Rhode Island Airport Corporation

ADDENDUM NO. 001
Invitation for Bid No. 26298 – Sound Mitigation Program – Phase 4
Group A
T. F. Green Airport
Warwick, Rhode Island

Prospective Bidders and all concerned are hereby notified of the following changes in the Request for Bids document for the Sound Mitigation Program Phase 4 – Group A at T. F. Green Airport, IFB No. 26298. These changes shall be incorporated in and shall become an integral part of the contract documents.

Greenless, Lillian
3428 West Shore Rd.
Attic

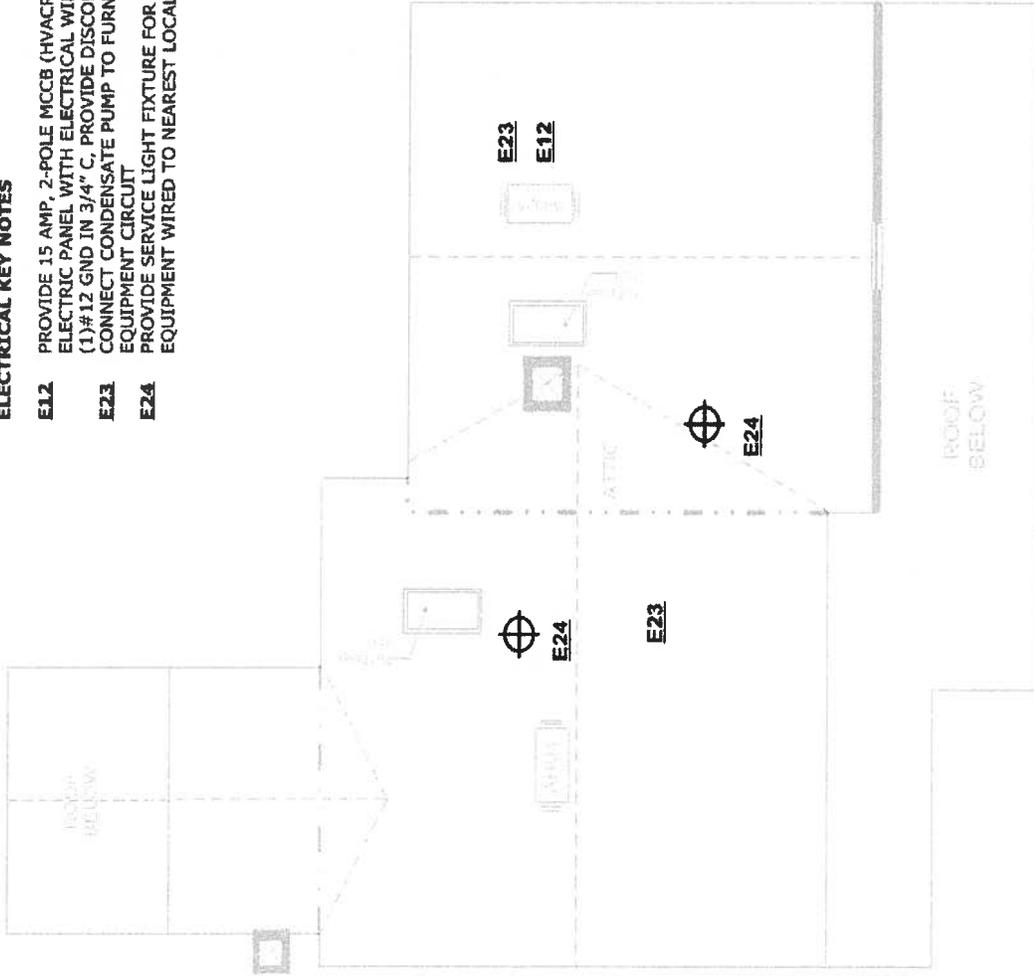
1. Sheet 15: replace keynote E12 on the electrical attic plan.

Sheet No:
2 R of 11

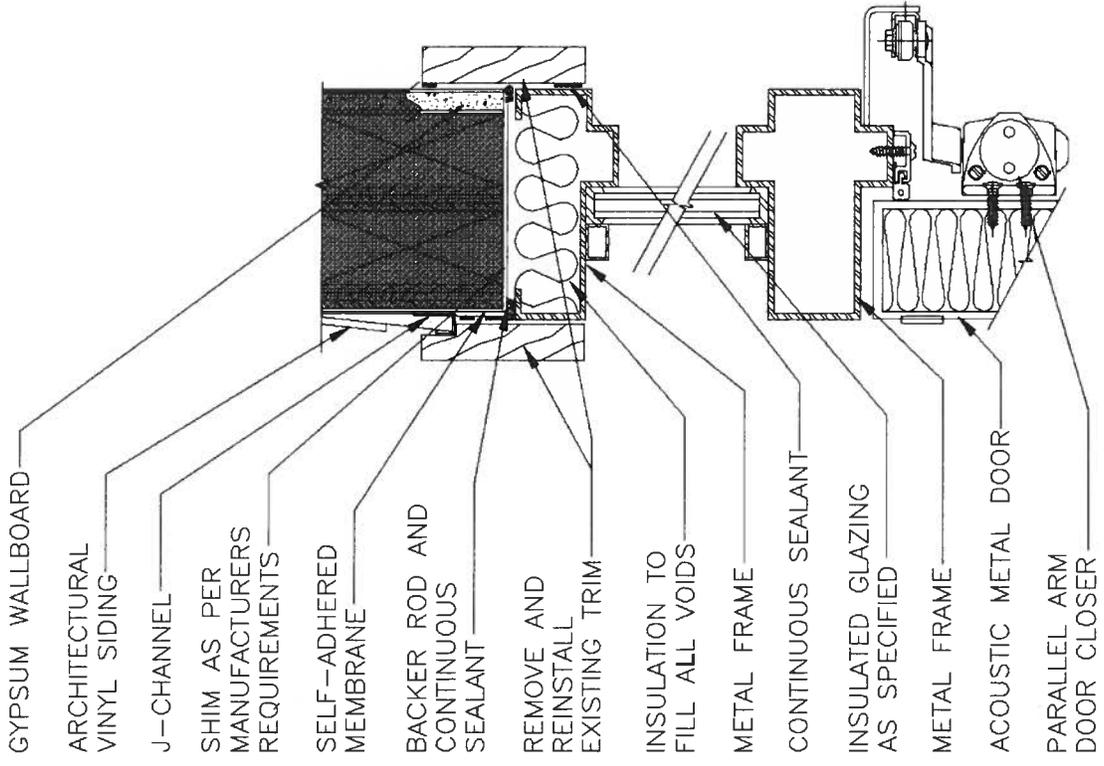
1. Sheet 1: delete General Contractor Note "Remove and reinstall panic bar and mechanical closer from doors being treated." New hardware will be provided.
2. Sheet 2: see new window schedule comments and attached storm window detail W4-0047.

3. Sheet 2: door schedule details referenced as SK-A and SK-B have been added, see attached.
4. Sheet 2: delete tempered glass at window #9 from the window schedule.
5. Sheet 2: see new comments at doors "A" and "B".
6. Add sheets 6R - 11R for SK-A metal door details. See attached.

Jennings
205 Carolyn st.
Attic

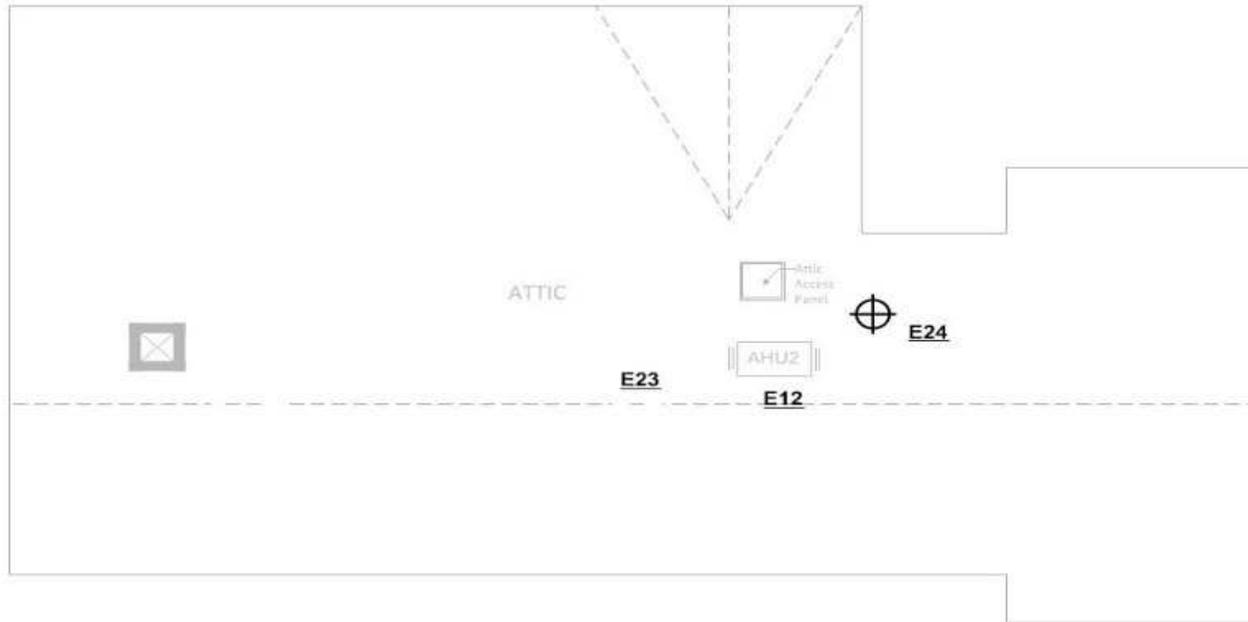
1. Sheet 11: delete note E25 and add note E12 on Electrical Attic Plan.

Sheet No:
3 R of 17

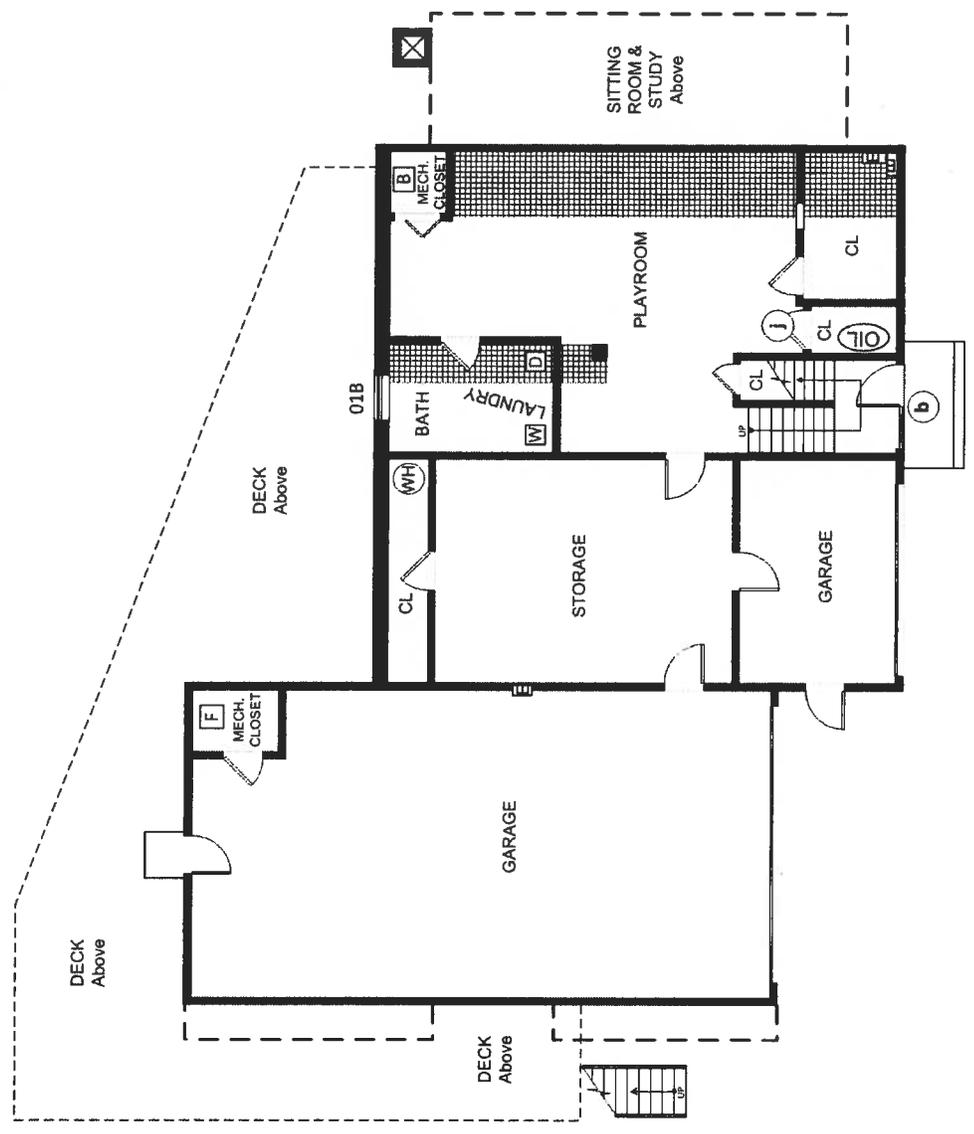
1. Sheets 2 & 3: replace detail "W4-0017" at windows # 17 thru 22 and 31 thru 33 with detail "SK-A".
2. Sheet 10: new SK-A detail.

Electrical 1st Floor Plan

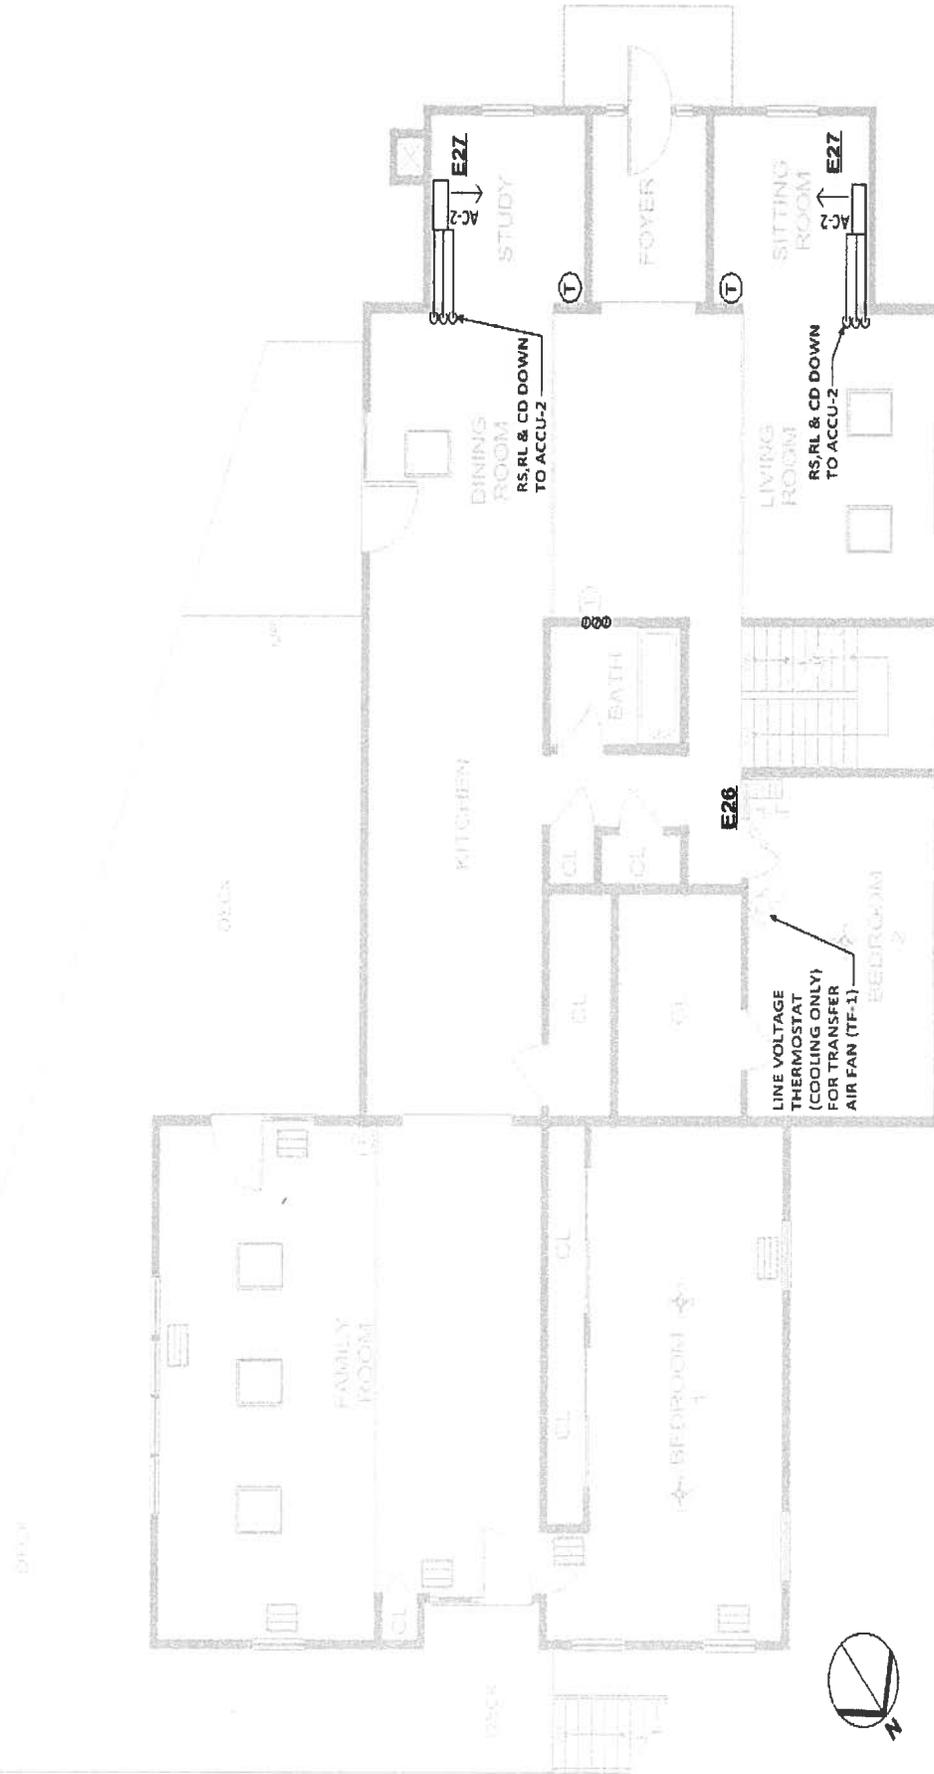
1. Sheet 3R: First Floor Plan, added note for constructing mechanical closet suspended under bedroom 2 & 3 closet.
2. Sheet 2: Window and Door Schedules, delete storm window treatment to sky-light #11.
3. Sheet 4: Second Floor Plan, replace duct soffit detail with C1-0003.
4. Sheet 9: 1st Floor Electrical Plan, keyed in note E26 for transfer fan in Family Room.

- E26** PROVIDE ELECTRICAL POWER, 120V, 1 PTN. OFF OF NEWEST RECEPTACLE OUTLET CIRCUIT TF-1.
- E2Z** AC-# IS FEED ELECTRICAL POWER FROM ASSOCIATED ACCU-# CIRCUIT. CONNECT AC-# ACCU-# CIRCUIT
